**ADDENDUM NO. 1
SABINE RIVER AUTHORITY OF TEXAS
Lake Fork Fence Improvements RFB# 23-0701**

THIS ADDENDUM IS ISSUED FOR THE PURPOSE OF AMENDING THE CONTRACT DOCUMENTS FOR THE SABINE RIVER AUTHORITY OF TEXAS, AS FOLLOWS:

SABINE RIVER AUTHORITY
OF TEXAS
LAKE FORK DIVISION
FENCE DETAILS

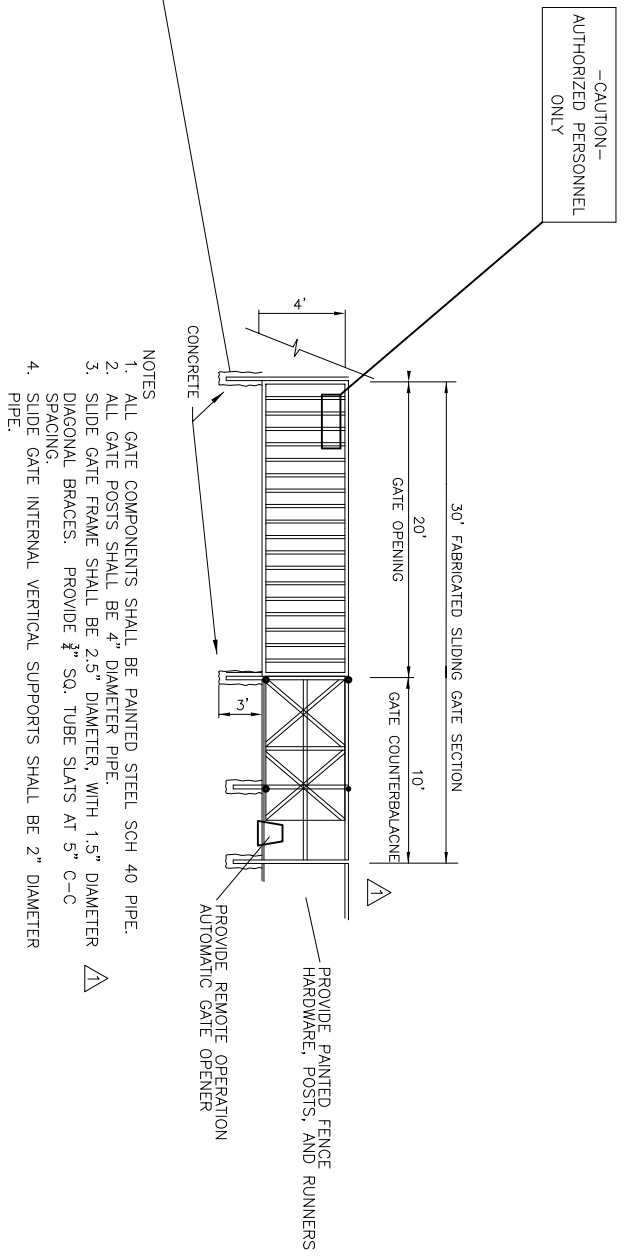
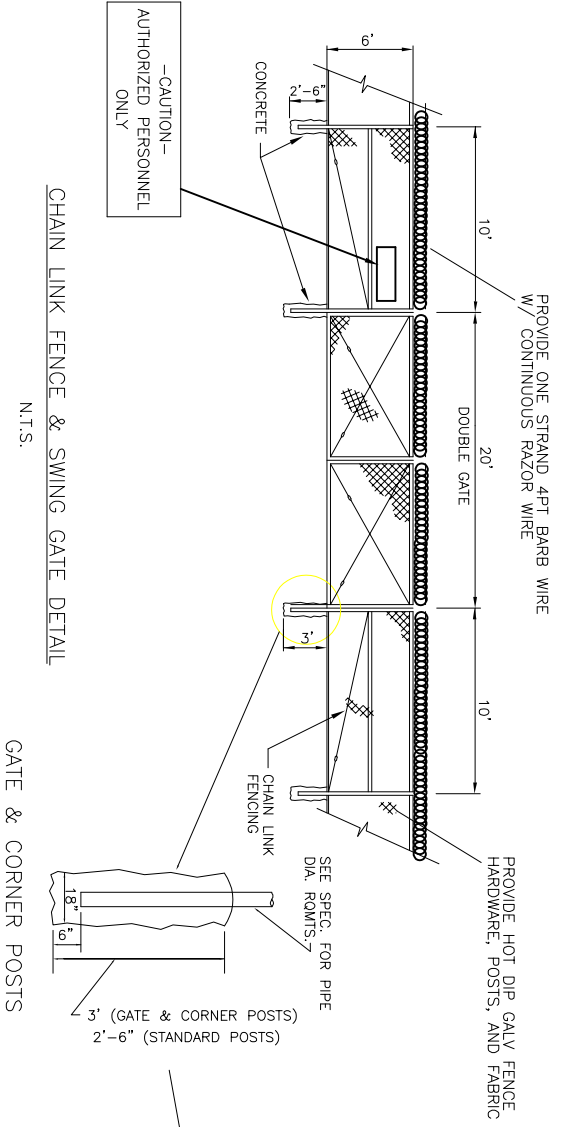
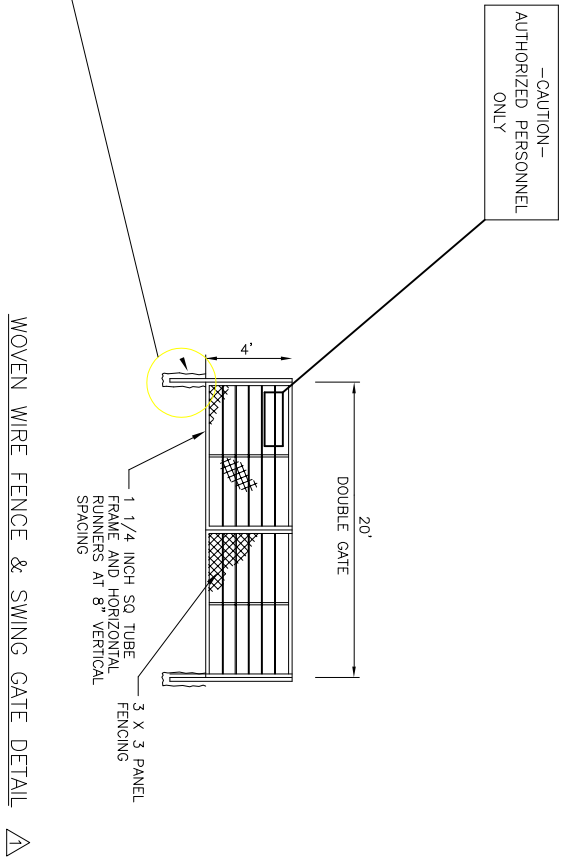
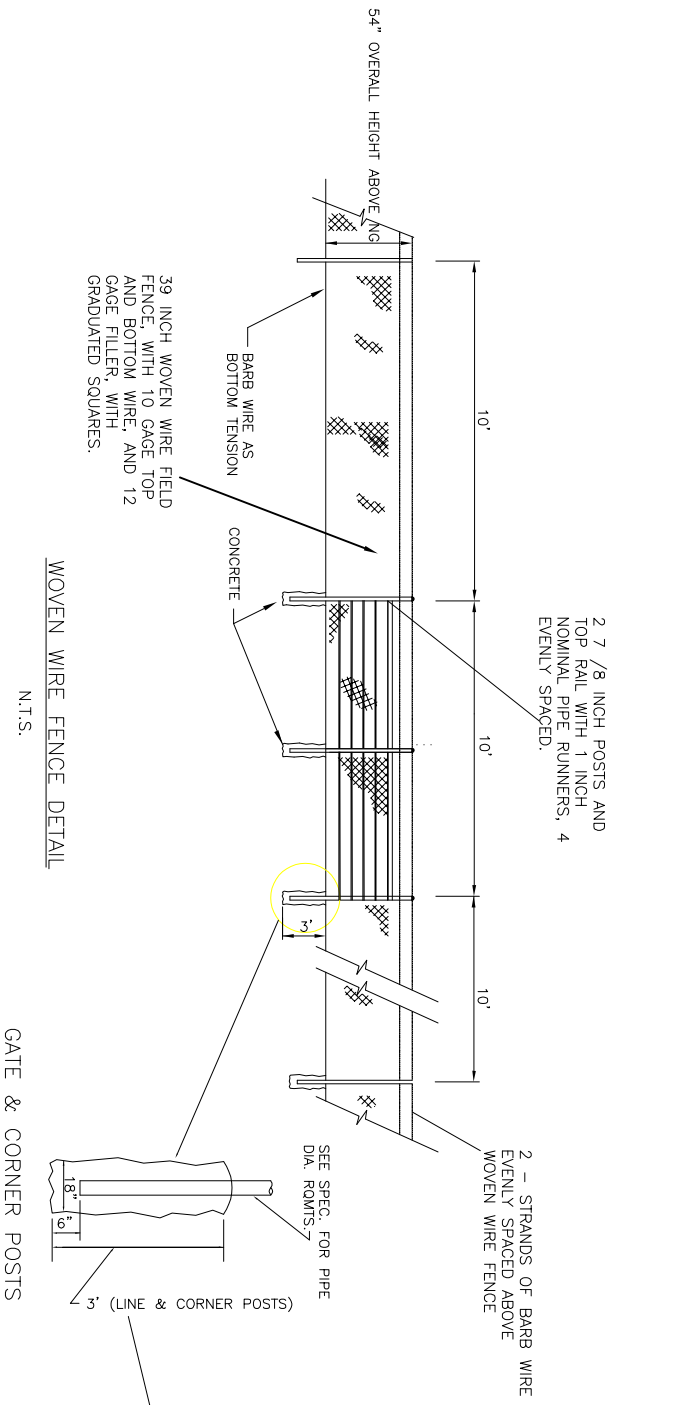
- Delete Plan Sheet 3 of 3 - Fence Details and replace with the attached. The automatic slide gate has been revised, and gate detail added for the woven wire manual gate areas.

- S & R Cabin Fence - Contractor shall leave a 16 ft. wide gap between fence sections centered on the existing asphalt road to allow for SRA installed swing gate.
- Contractor shall provide Automatic gate opener as shown on plan sheet 3. Opener shall be as follows or approved equal:

Lift Master CSL 24VDC Solar for slide gate , with one (1) key pad gate opener on the exterior, and in ground safety loop opening sensor on the interior.
